CITY OF FREDERICKSBURG HISTORIC REVIEW BOARD

TUESDAY, SEPTEMBER 13, 2022

6. CERTIFICATE OF APPROPRIATENESS APPLICATIONS

01 SCHEMATIC NORTH ELEVATION
SCALE: 1/4" = 1'-0"

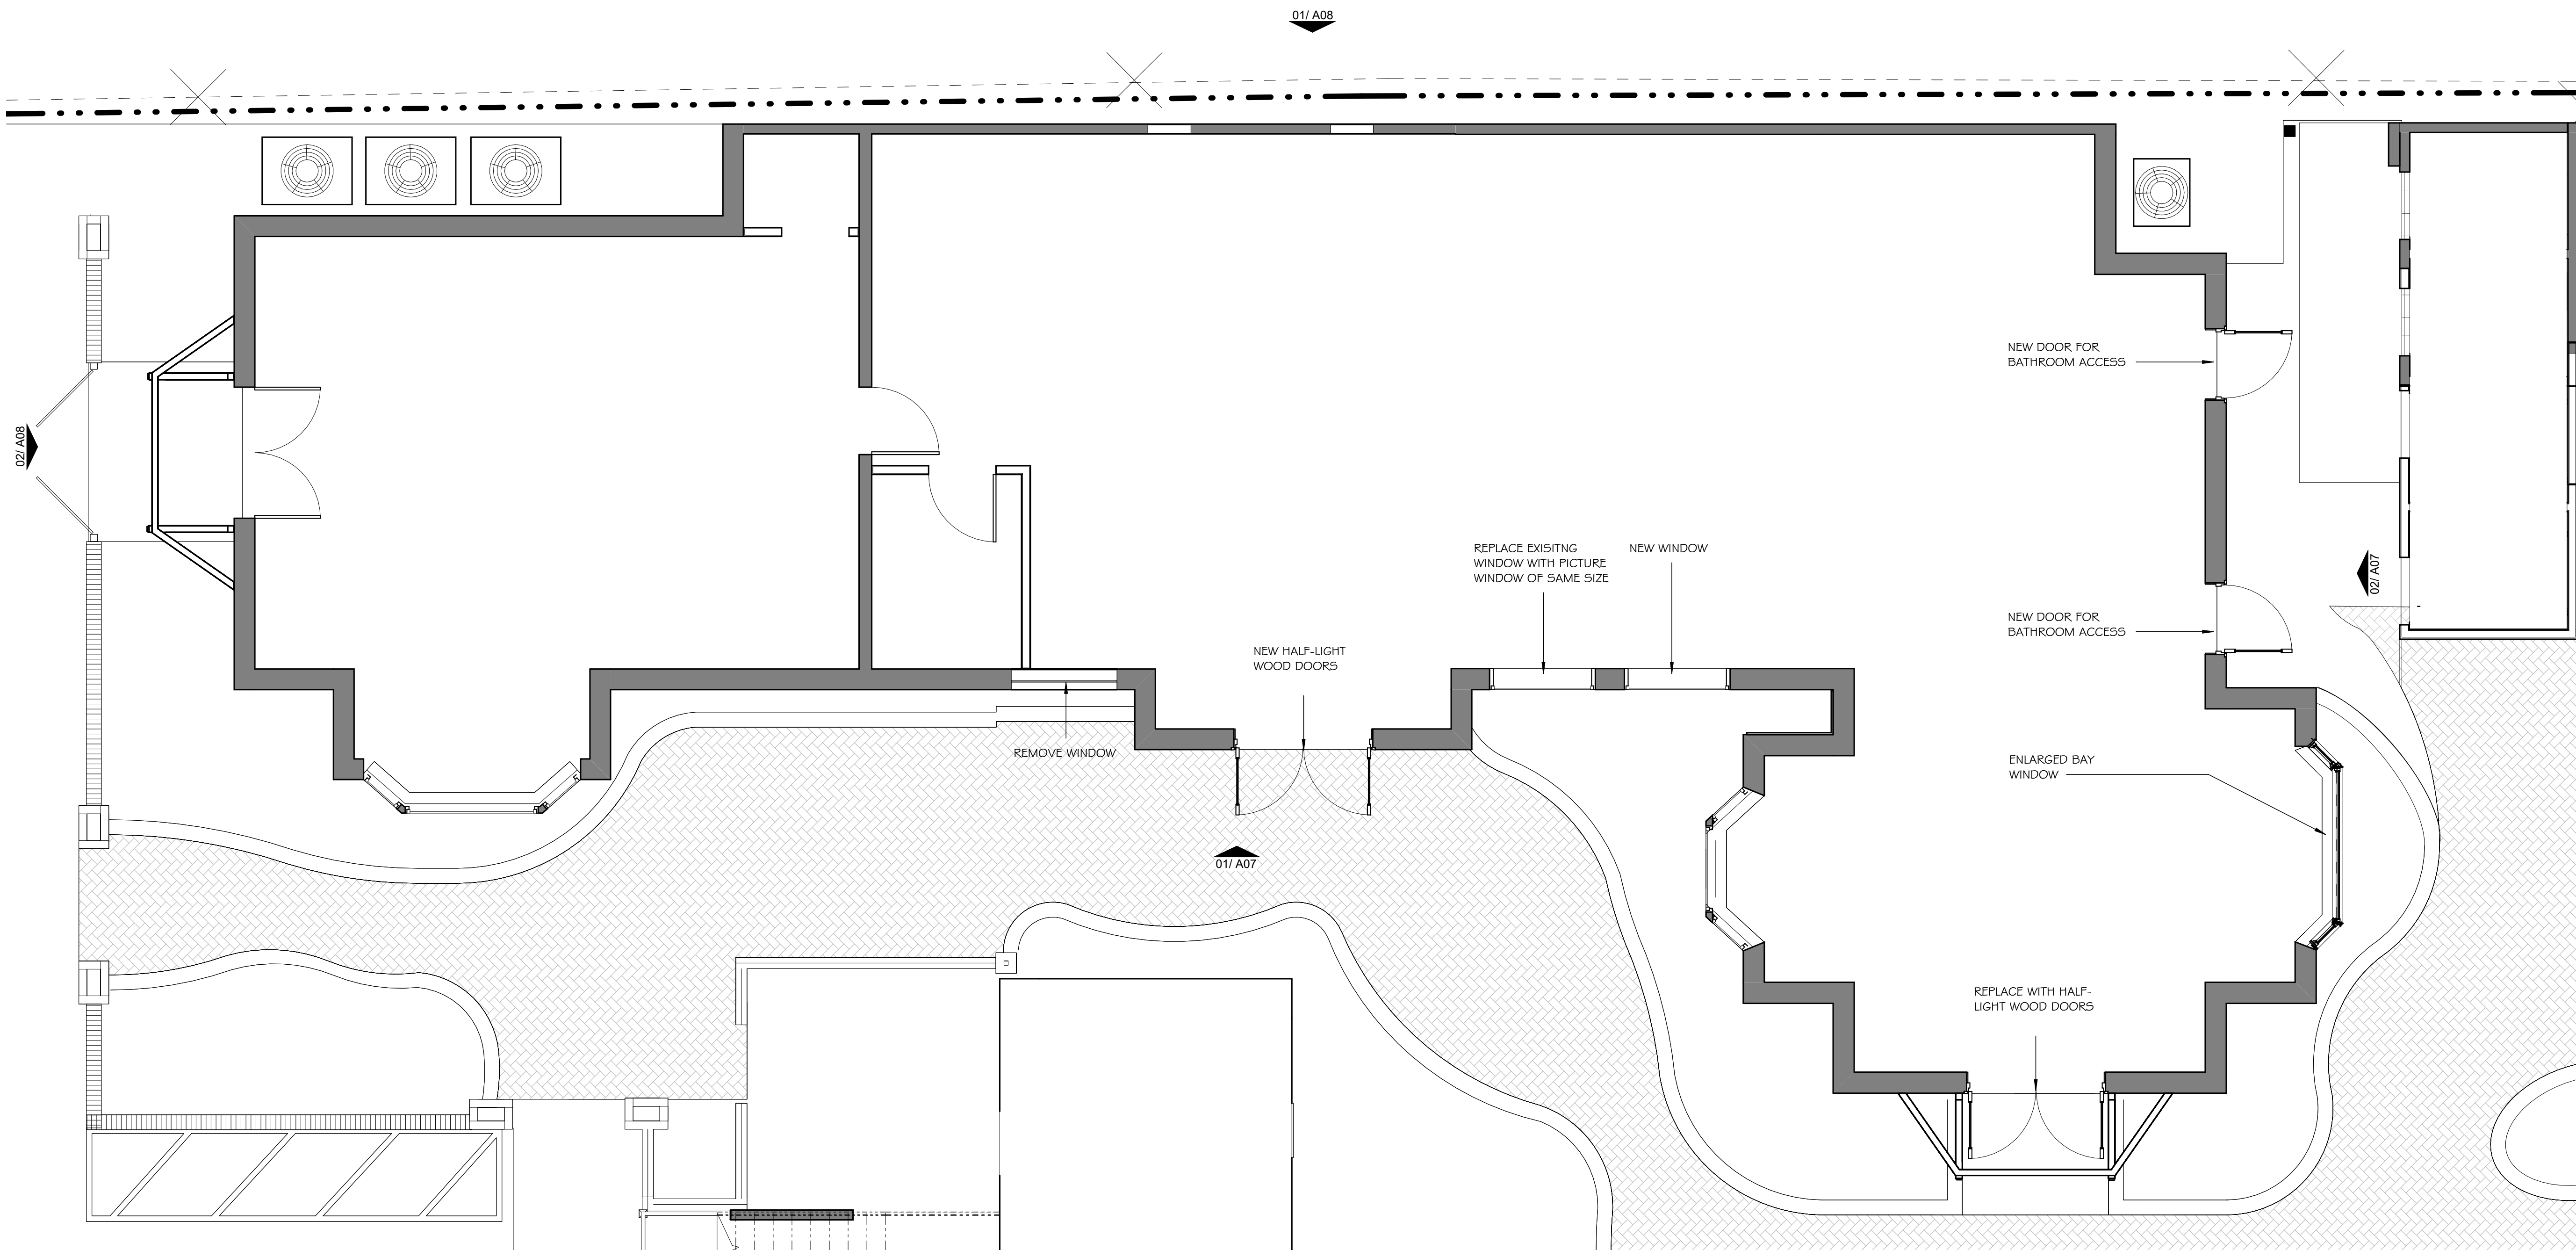
1. Replace the following existing windows with new metal clad windows with similar clad as existing to be clarified in elevations
 - a. Enlarging north facing bay window and replace with similar window style and configuration to original

- b. Removal of window on east wall due to conditions change in the interior. Window would be interrupted by an interior wall
 - c. Replacing window on east façade to remove divided light to match the other windows on the building

- d. Windows to be Marvin Ultimate Picture windows
2. Alterations to brick walls
 - a. Extruding mortar to be removed and repointed
 - b. Whitewash or painted (TBD) will be added in order to even out previous paint applications that have left the surface with uneven colors and layers of paint

- c. If painted, the color will match surrounding buildings
3. Wood siding on west exterior wall to be painted to match surrounding buildings
4. Window to be added to match existing window on east façade for additional natural light; reference plan and elevation

5. Two exits, half-light wooden doors, to be added to north exterior for access to new and existing restrooms on the south end of 421 Main St.
6. Replace window on east wall with a pair of half-light wooden doors for flow and egress

- a. Awning to match main façade to be added for weather protection
 - b. Shown in plan and elevation
7. Replace eastern main façade doors with a pair of half-light wooden doors to provide continuity in overall design aesthetic

Building 421 E. Main St.
EAST

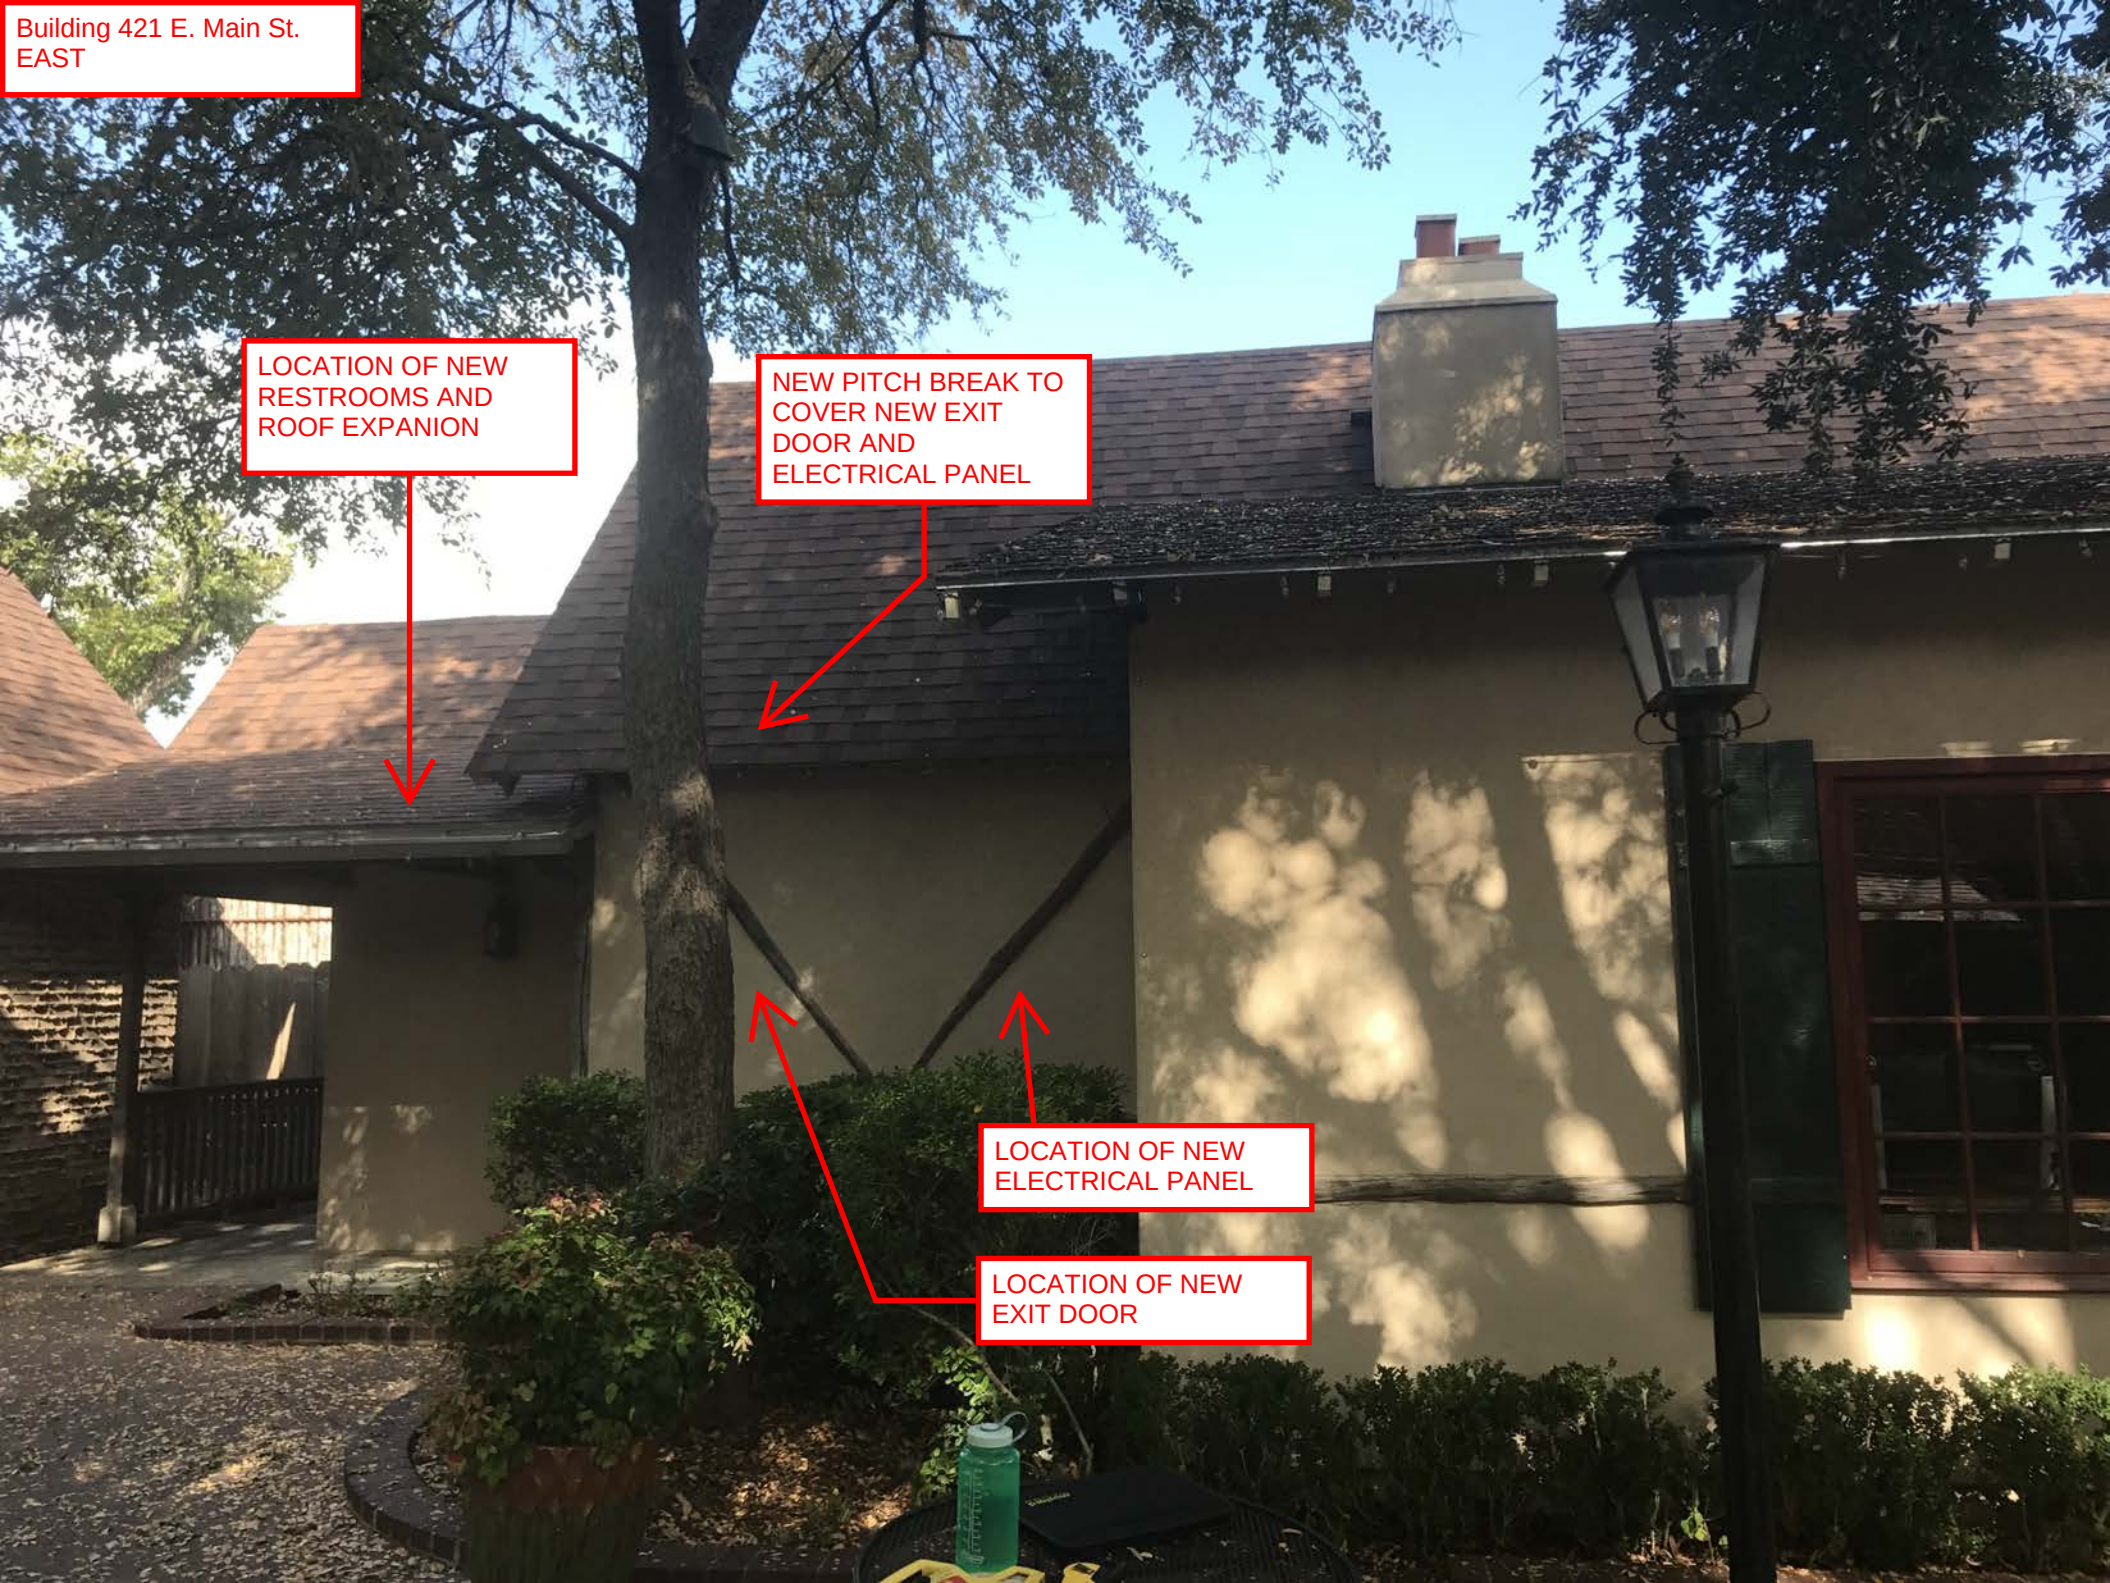
DOORS TO BE
ENLARGED AND
REPLACED WITH
HALF LIGHT
WOODEN DOORS

WINDOW TO BE
ENLARGED NEW
WINDOW; TO BE
PICTURE WINDOW

LOCATION OF NEW
RESTROOMS AND
ROOF EXPANION

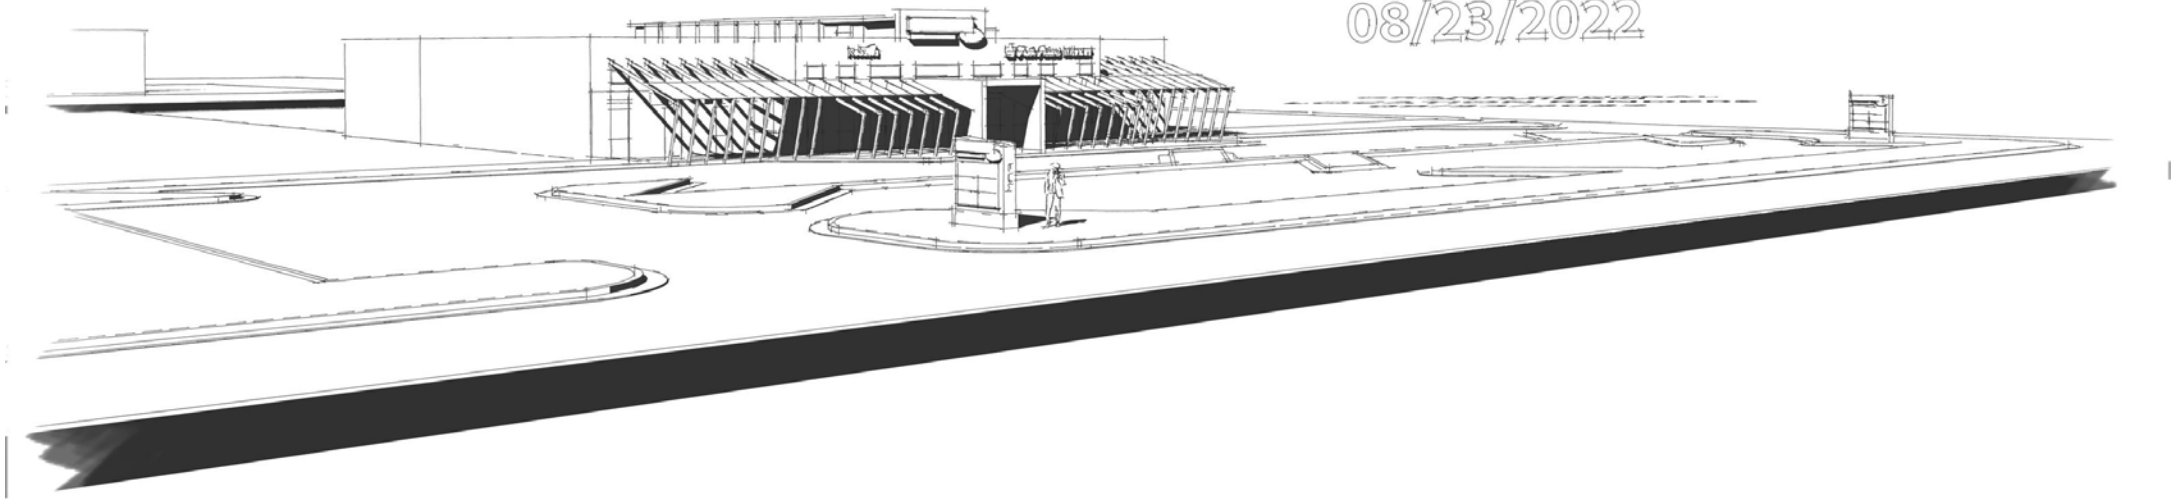
Staff has worked with the applicant to reduce the height of the monument sign. As an integrated business a 15' sign is allowed per C1.5 zoning. Given the pedestrian nature of this neighborhood a 15' tall sign would be out of character. As such, the applicant has proposed to create two 8' tall monument signs to be located at opposite ends of the lot along N. Milam.

The zoning ordinance does not speak to allowing two smaller monument signs in lieu of one large monument sign. If the Historic Review Board recommends this design the applicant must obtain a variance from the Zoning Board of Approval.
